Access Compliance Report

Public Rights-of-Way

(Curb Ramps)

Intersection ID: 44317	Main Street: E_9TH_ST	Cross Street: N_CALDWELL_ST	Location: NW
ADA ID: F114E2FAC58F	Ramp Type: Perp	Initial Pass/Fail: Fail	Overall Compliance: No
Severity Score: 22.5			
Codes/Mitigation Info/Possible Solution		Field Measurements/Component Compliance

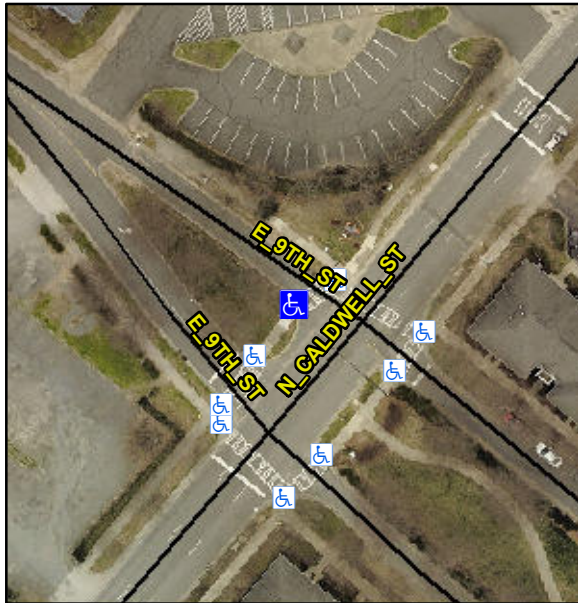
Not Found, R304.5.1, R304.2.2, R304.5.3

Compliance	Description	Data	Compliance	Description	Data
N/A	Ramp Length (in)	42.0	No	Ramp Slope (%)	8.4
No	Ramp Width (in)	44.0	No	Ramp XSlope (%)	3.7
N/A	Flare Type LT	N/A	N/A	Flare Type RT	N/A
N/A	Flare Slope LT (%)	N/A	N/A	Flare Slope RT (%)	N/A
N/A	Flare Traversable LT?	N/A	N/A	Flare Traversable RT?	N/A
N/A	Landing Length (in)	N/A	N/A	DWS Provided?	N/A
N/A	Landing Width (in)	N/A	N/A	DWS Contrast?	N/A
N/A	Landing Slope (%)	N/A	N/A	DWS Length (in)	N/A
N/A	Landing X Slope (%)	N/A	N/A	DWS Full Width?	N/A
N/A	Landing Curb? (Y/N)	N/A	N/A	DWS Offset (in)	N/A
N/A	Shared Landing?	N/A			
N/A	Gutter Ponding?	N/A	N/A	Gutter Slope (%)	N/A
N/A	Gutter Lip Ht (in)	N/A	N/A	Gutter X Slope (%)	N/A
N/A	Painted X Walk1?	Yes	N/A	Painted X Walk2?	N/A
	X Walk 1 Direction	To NE		X Walk 2 Direction	N/A
N/A	X Walk 1 Width (in)	105.0	N/A	X Walk 2 Width (in)	N/A
	X Walk 1 Slope (%)	3.3		X Walk 2 Slope (%)	N/A
	X Walk 1 X Slope (%)	2.1		X Walk 2 X Slope (%)	N/A

Remove & Replace Entire Ramp.
